An
Coimisiún
Pleanála

FSC Report

ACP-323255-25

The Links, Block C, Woodbrook
Avenue, Woodbrook, Co. Dublin

FIGURE 6

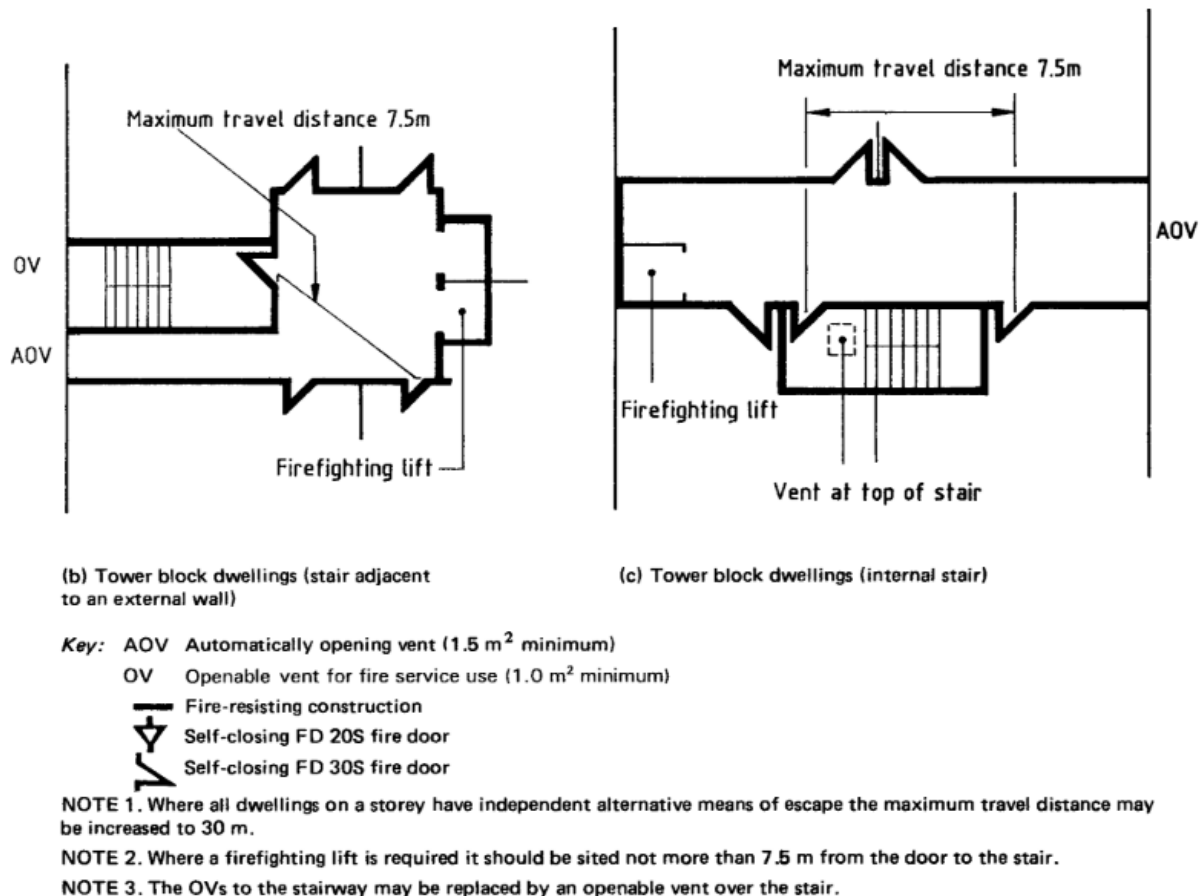
The argument is made that the lifts in the proposed development are not firefighting lifts but that even if they were (as per Figure 6 above), there would be no requirement for the lift landing doors to have any smoke leakage rating, and the lifts (in their view) could open directly into a shared common corridor.

- They emphasise the fact that the lifts in Figure 12 of BS5588 Part 1 are identified as firefighting lifts and as the proposed lifts in this block are not firefighting lifts this figure is not applicable. In addition, the case is made that even if the lifts were firefighting lifts the arrangement in Figure 12 (of Part 1) where the lifts open directly into a shared common corridor would not be acceptable. They point to Section 5.3.2 of TGD B which they say supersedes Figure 12 and recommends “a *firefighting lobby should be provided*” whereby “*there should not be direct access to a flat or ancillary accommodation from a firefighting lobby*” and a “*firefighting lift should be approached through a firefighting lobby*”.

- While they agree that Figures 12(b) & (c) refer to firefighting lifts, they make the point that there are no other figures that show the proposed design and as such these figures were the most appropriate figures to reference. The appellant argues that even though firefighting lifts are not required the guidance given in Section 7.2.3 of BS5588 Part 5 clearly distinguishes that common corridors in residential

- With regards Figures 12(b) & (c) of BS5588 Part 1, while I agree that there is no figure in this standard that reflects the design being proposed by the appellant, I would share a similar view to that of the BCA. The figures referenced in BS5599 Part 1 show firefighting lifts opening directly into the common corridor which would not be acceptable under Section 5.3.2 of TGD B. Diagram 33 of TGD B clearly shows that a building provided with a firefighting lift must opening into a dedicated firefighting lobby and not into a common corridor.

FIGURE 9

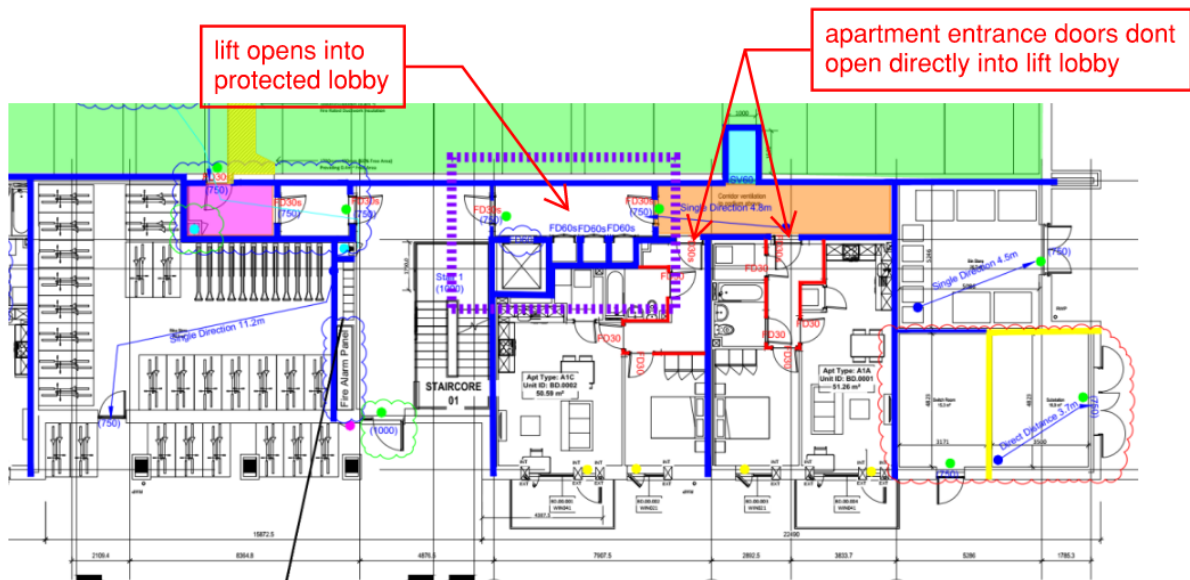
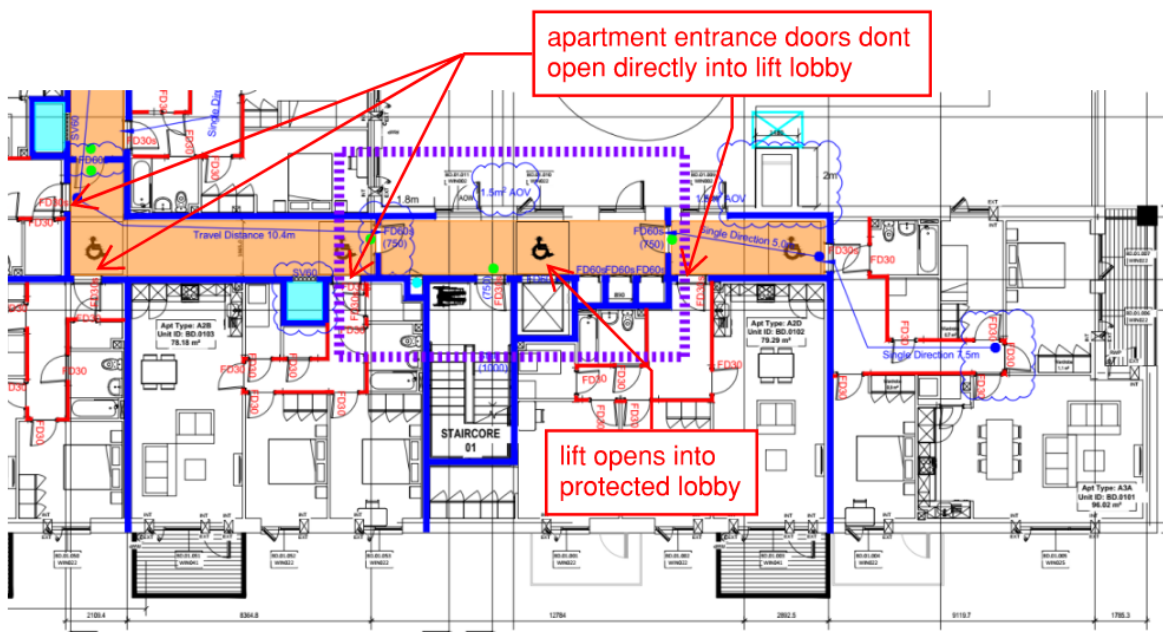
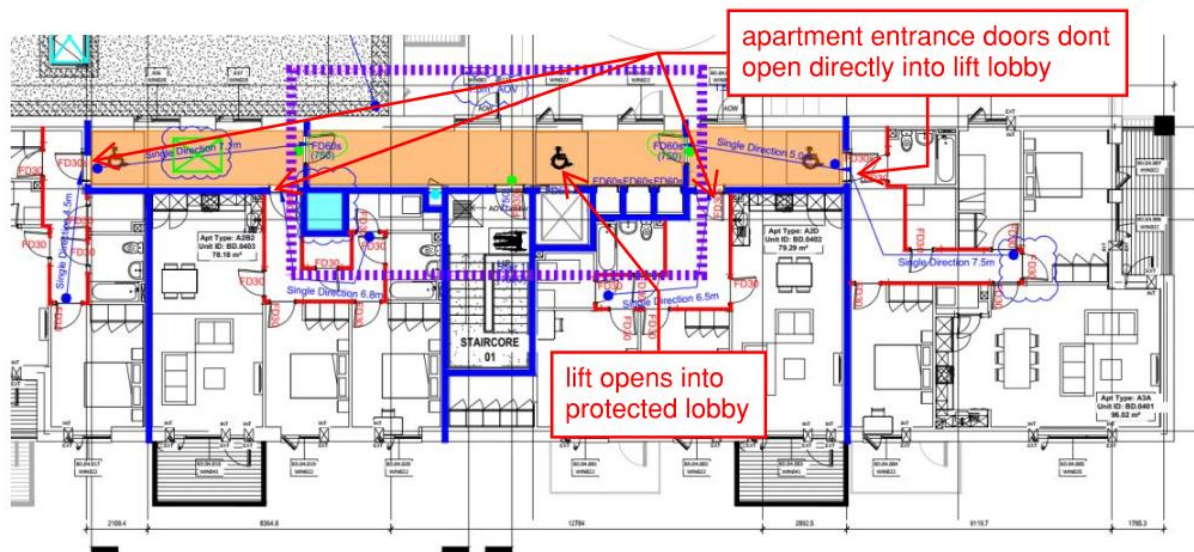
The plans for Block D included in the BCA report clearly show that the lift opens into a protected lobby that has no apartments opening directly off it, see below.

As can be seen from Figures 9-11 above, the lift lobby arrangement in Block D layout bears no similarity to those being proposed in Block C.

FIGURE 12

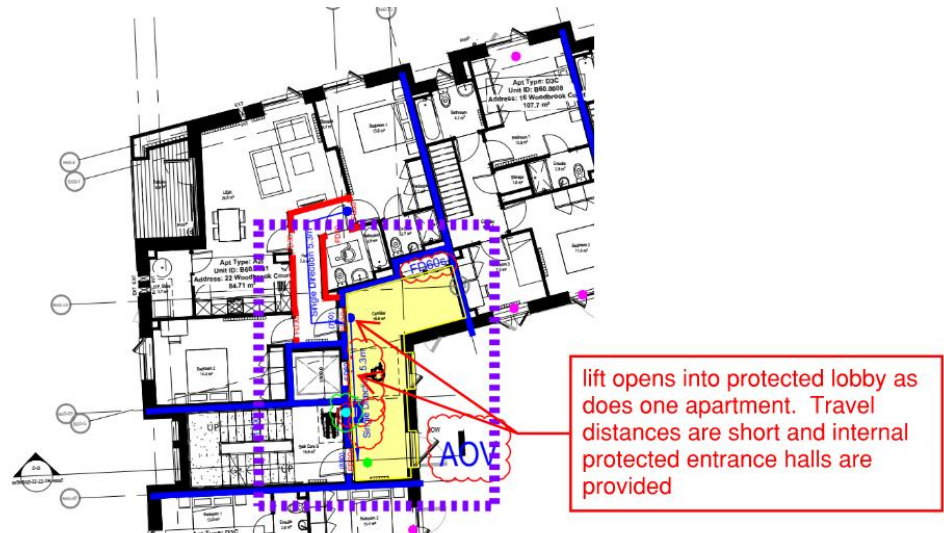
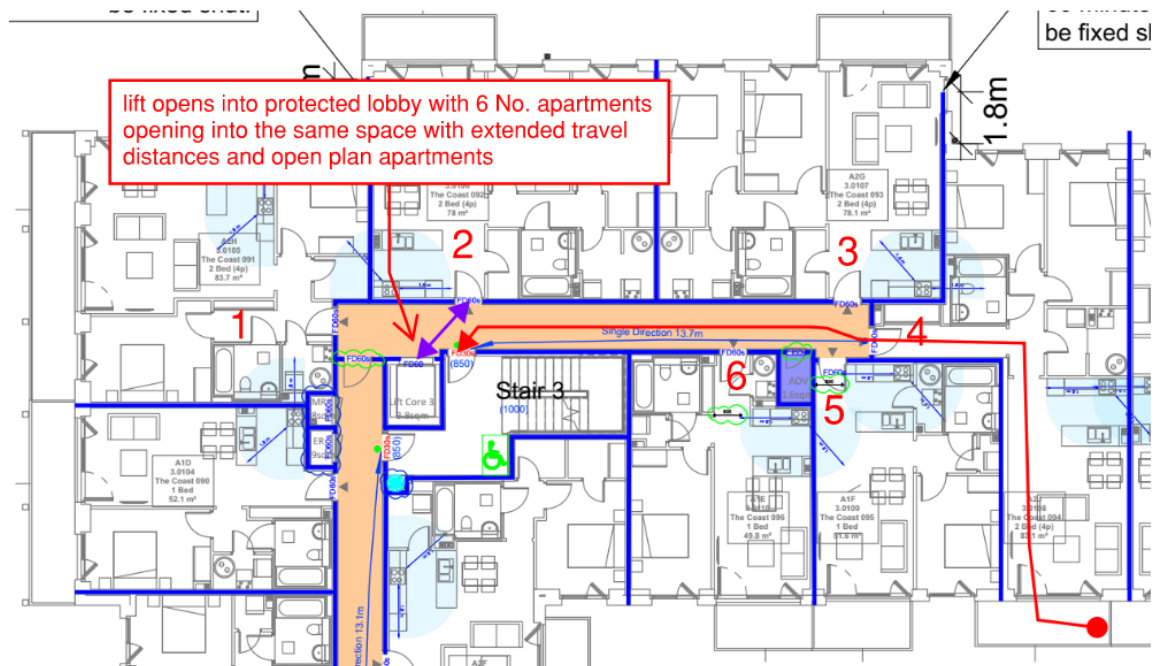
The plans included in the BCA report for Block 60, in my view, also differ to those in Block C as they show 1 No. apartment on the ground, first and third floors opening into the same lobby as the lift. The second floor has a completely different layout, as alternative means of escape is provide for evacuees on this floor.

Figure 12 below shows a typical floor layout approved for Block 60 which has the lift opening into a protected lift lobby shared with 1 No. apartment compared to Figure 13 for the proposed development which shows the lift opening into a lobby shared with 6 No. apartments. The differences between the layouts include shorter travel distances and the provision of protected entrance halls in Block 60.

On the basis of the above, I would be of the view that the layouts of Block D and Block 60 are not similar to those proposed in Block C.
